## **REPORT**

### **4<sup>th</sup> meeting of GRRF Informal Working Group on Automatically Commanded Steering Function**

Venue: Venue: Jasic Office Tokyo, Japan.  
Chairman: Mr. Christian Theis (D) and Mr. Hidenobu Kubota (J)  
Secretariat: Mr. Jochen Schaefer (CLEPA)  
Dates: 25.-27. November 2015  
Website: <https://www2.unece.org/wiki/display/trans/ACSF+4th+session>

Survey on the transition time from ACSF to Manual Driving

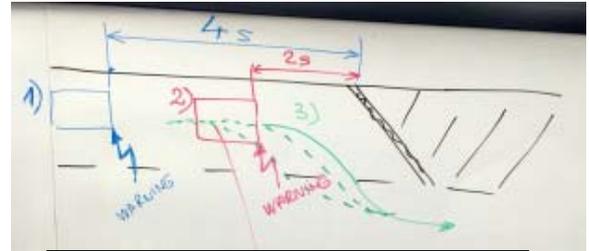
(OICA): explained the warning cascade on the whiteboard

(SE): has concerns about the numbers

(NL): confirms statement of SE, he thinks, the numbers may be too low.

(OICA): 4s should be sufficient. Also calculations in the SAE document is showing this.

Warning time = 2s + car slows down  
⇒ TTC increases up to 4s
